World Forum for Harmonization of Vehicle Regulations

Working Party on General Safety Provisions

Proposal for a new UN Regulation on the approval of devices for reversing motion and motor vehicles with regard to the driver's awareness of vulnerable road users behind vehicles

Submitted by the Informal Working Group on Awareness of Vulnerable Road Users Proximity*

Figure 1
Example for the measurement by maximum variation

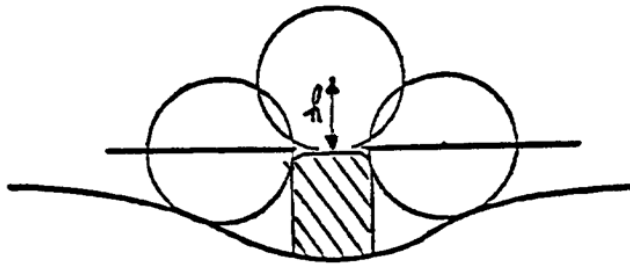
Japan: Based on last IWG discussion, how do we manage impact test or radius of curvature?

Figure B
Test object locations

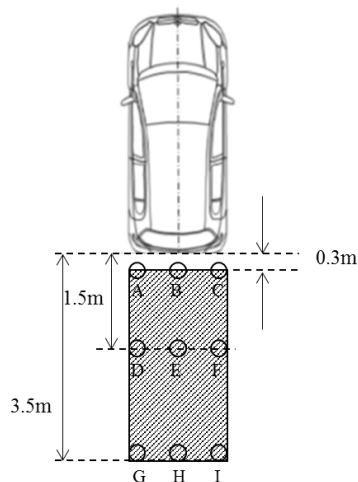
~~Test object locations can be added between A to I by the Technical Service.~~

Japan: Removal miss.
